**ADDENDUM #1,
October 28, 2009**

NAME OF PROJECT: B09-109SE North End and South End Route 25 Bus Stop Improvements
BID SUBMITTAL DATE: Thursday, November 5, 2009 at 2:00 PM

FIGURE 6: STANDARD INLET DETAIL D-10-R

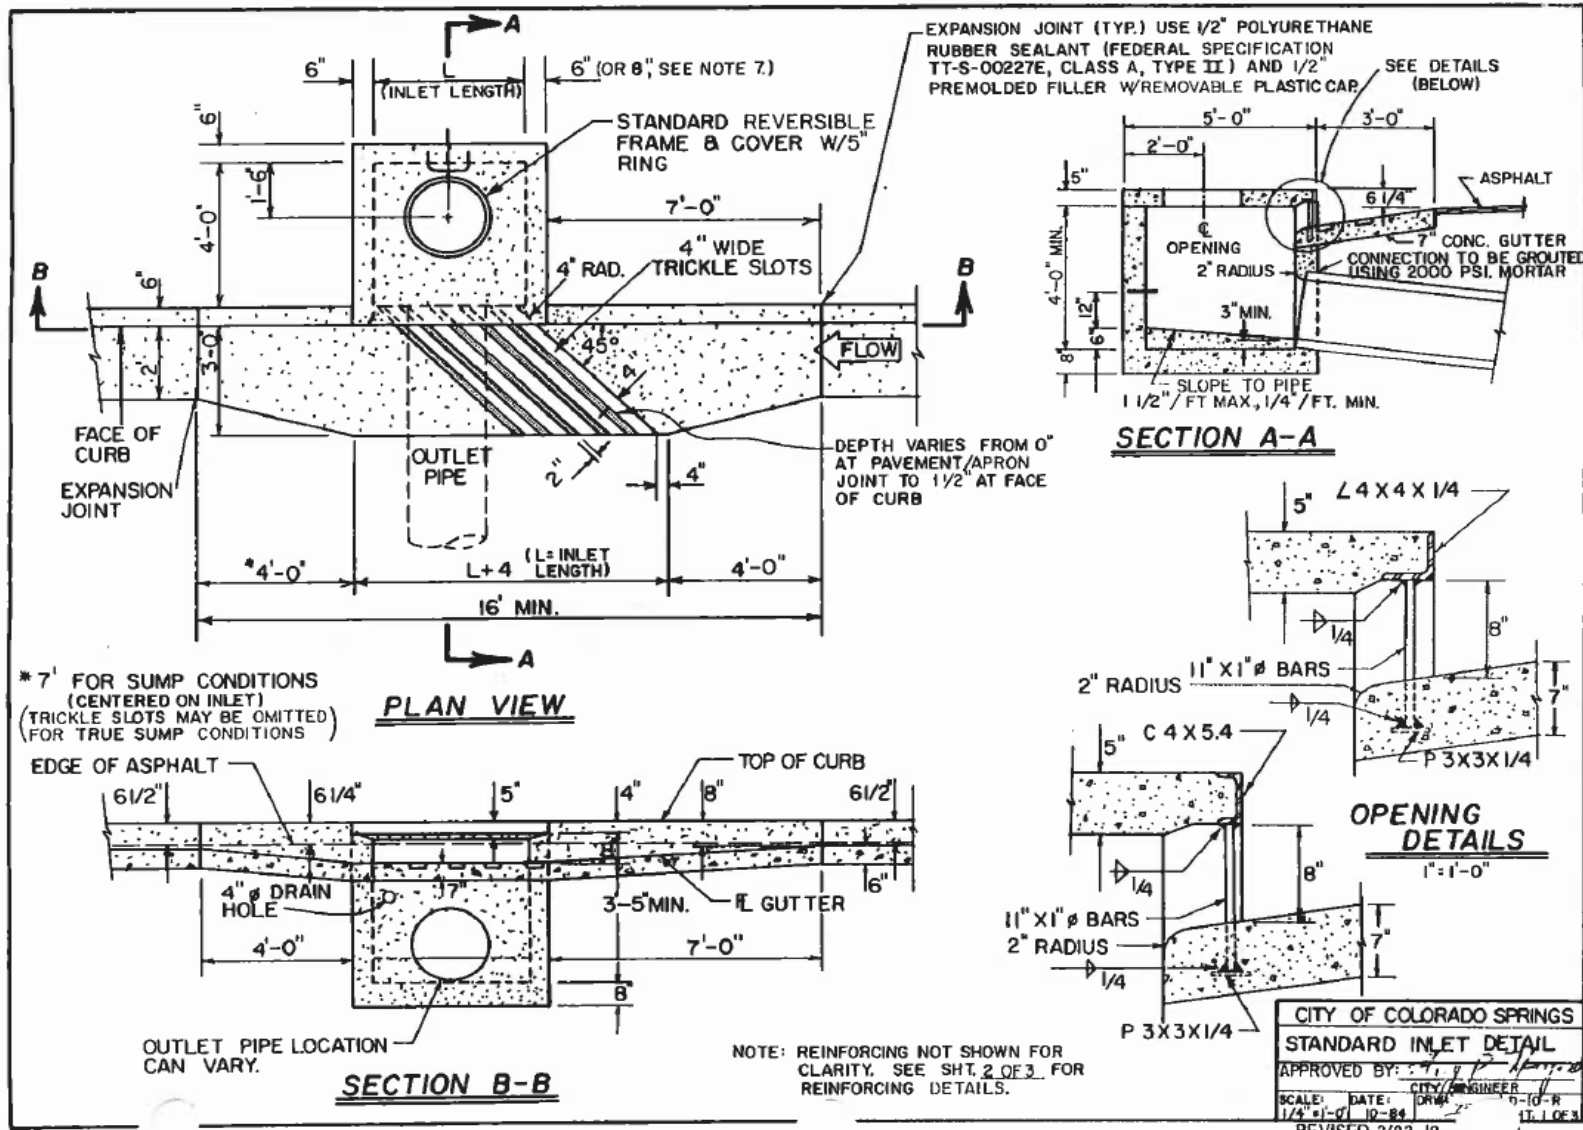
- 1800 sf Asphalt Patch
 - 2-14' Inlets per City Standard Detail D-10-R
 - 30 lf 24" RCP Pipe

- 7. **Schedule H – Remove Item #9: Remove Bubbler**
Remove this reference in its entirety
- 8. **Schedule H – Add Item # 11: Install D-10-R Inlet (SEE ATTACHED DRAWINGS)**
Installation of D-10-R Inlet will be paid for at the contract unit price by the number of inlets by length in feet actually constructed and accepted by the Engineer, and in accordance with Section 630 and Standard Drawing D-10R of the City of Colorado Springs Standard Specifications.
- 9. **New Schedule A – BID FORM**
Use the revised Schedule A Bid Form incorporating the changes of Addendum 1
